**ADDRESS: 264 WATSON**

**APPLICATION NO: HDC2024-00660**

**HISTORIC DISTRICT: BRUSH PARK**

**SCOPE: ERECT COVERED DECK AND STAIR AT REAR**

**Current rear porch proposed for removal.**

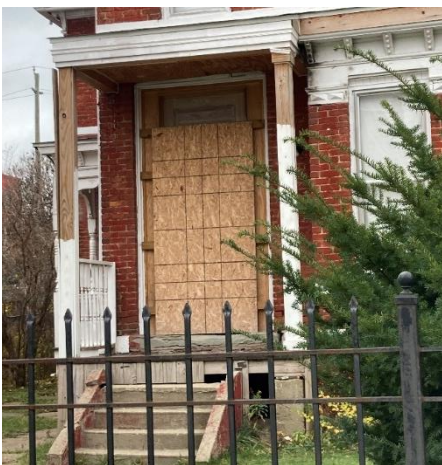
- Erection of the rear wood porch sometime after 1981 - The 1981 drawings indicate the presence of a deck with a small, shed-roof overhanging canopy on brackets over the rear door. Also, a gabled roof enclosure was located at steps which led to the basement was present. Sometime after 1981, the basement door enclosure was removed and the current large wood canopy was erected. The current application proposes to replace the current wood porch and non-character-defining masonry deck with a new wood deck with wood handrails and guardrails and composite floor. Staff supports this approach

**Front porch, 2011. Google Streetview**

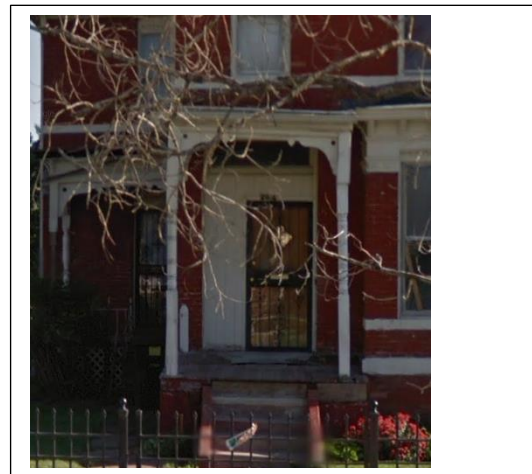
- Removal of the front porch and erect a new porch – Google Streetview images indicate the front porch was removed sometime between 2011 and 2013, leaving the masonry deck and steps. The current wood porch was erected 2021. The current application proposes to replace this non-historic front porch with a new wood porch, modeled on the details present at the existing historic-age side porch. Staff generally supports this proposal, although the applicant is seeking to demolish the historic east side porch and wrap the porch around to the east wall, which staff does not support. As noted above, the side porch appears to date from the building’s original date of construction. Also, the porch displays significant ornamental features which are illustrative of the building’s vintage/period of construction and Queen Anne style. As such, the porch is a distinctive, character-defining feature which should be retained.

**Front door, 2022. Google Streetview. Per the above photo taken by staff on 11/25/2024, the transom, wood infill, and door depicted in this image are now gone. A new wood door which fills the entire opening is current present. The applicant is seeking to install a new door and trim in the opening**

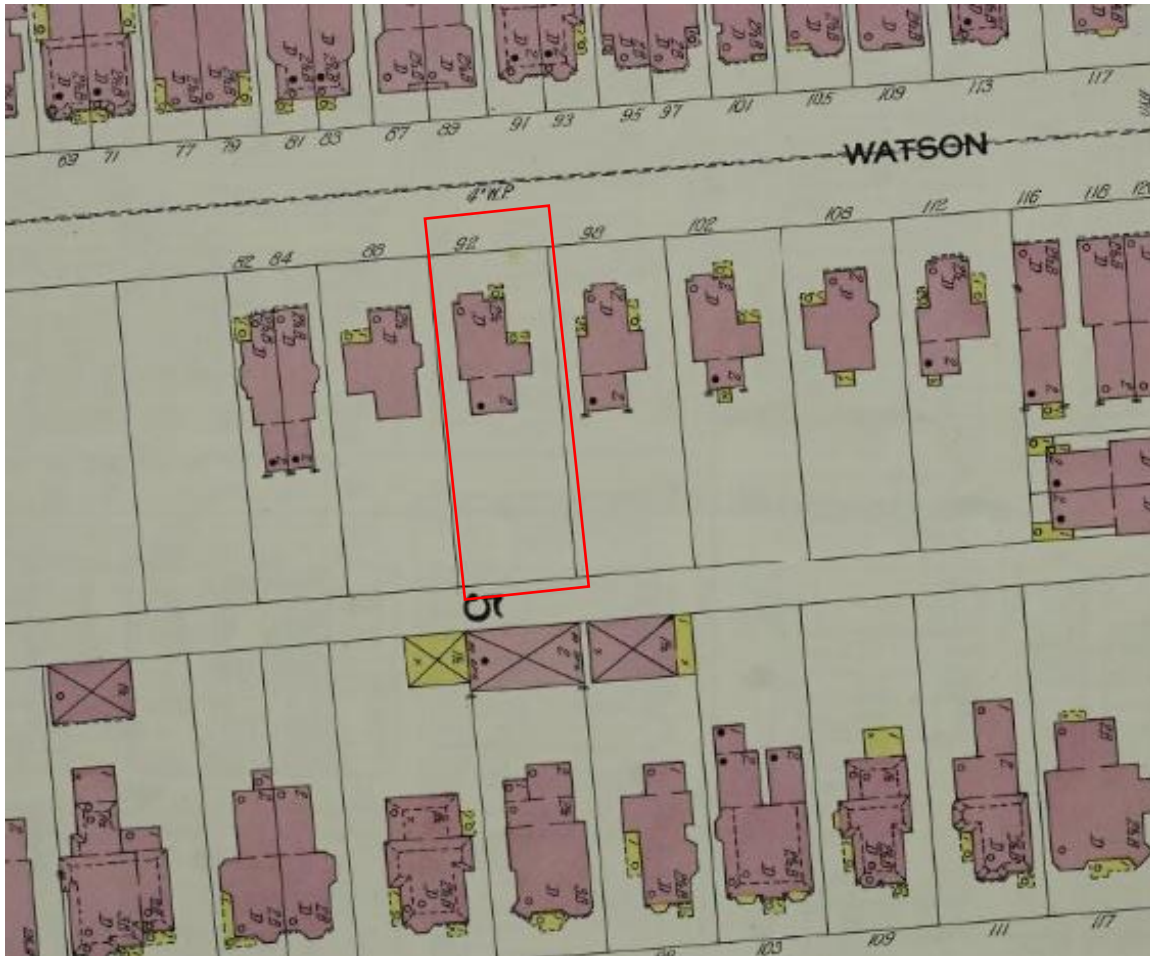
- Remove transom at front door and install new door which fills rough opening – Per the above designation slide, the front door opening was partially infilled with plywood and a non-historic age door. A transom topped the door. The doorway retained this configuration until 2022, when the transom, door, and plywood infill was removed and replaced with a new wood door. The current application does not propose to restore the transom. Rather, it seeks to install a new wood door and trim in the current round opening. As the transom was historic age and removed without HDC approval, staff recommends that it be restored.

- As noted above, the historic front door wood transom was removed recently without HDC approval by a previous owner. The current application does not propose to restore the transom. Staff recommends that it be restored as it was a distinctive character-defining feature.

264 Watson, 1887. Note that the building is addressed as 92 Watson at this time

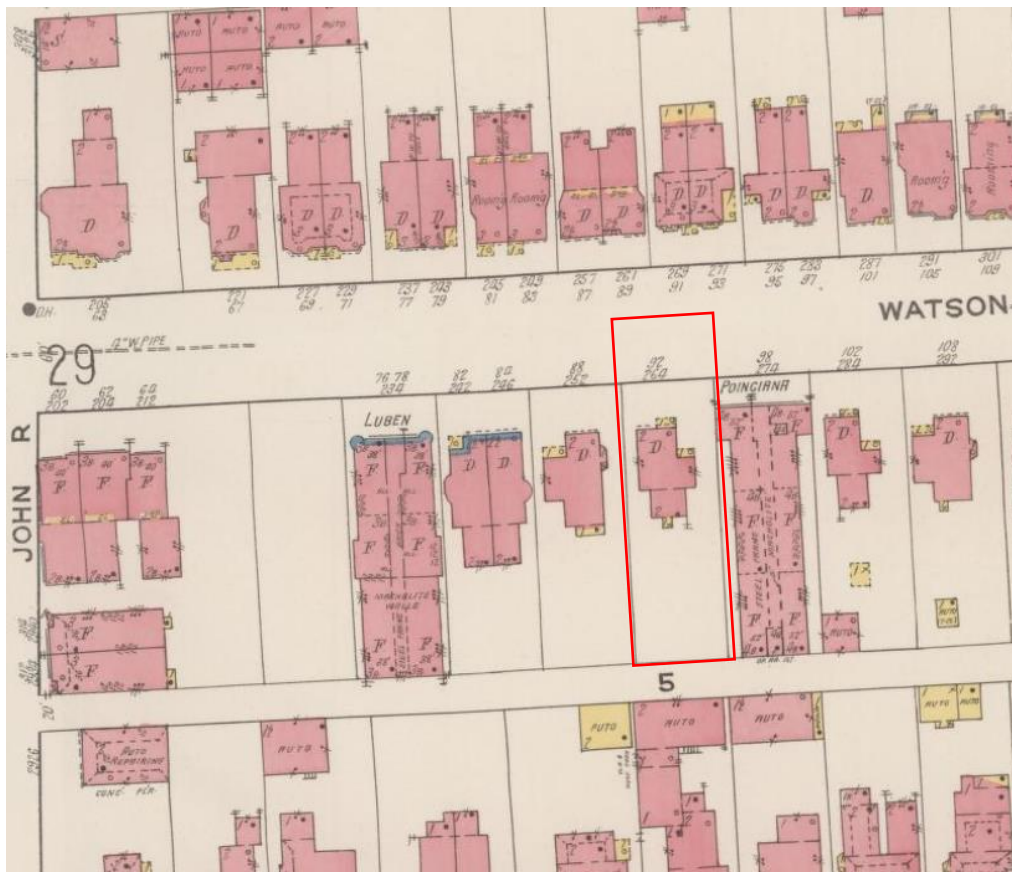
- See the below Sanborn Maps which indicate that the building never did have a wrap around porch. As noted above, staff does think the approach of removing a non-historic front porch and installing compatible new wrap around porch is appropriate in general, but in this specific case, the removal of the historic side east porch to accommodate the new wrap around porch is inappropriate as this porch is a distinctive, character-defining feature of the property because it appears to date from the building's original date of construction and displays significant ornamental features which are illustrative of the building's vintage/period of construction and Queen Anne style.
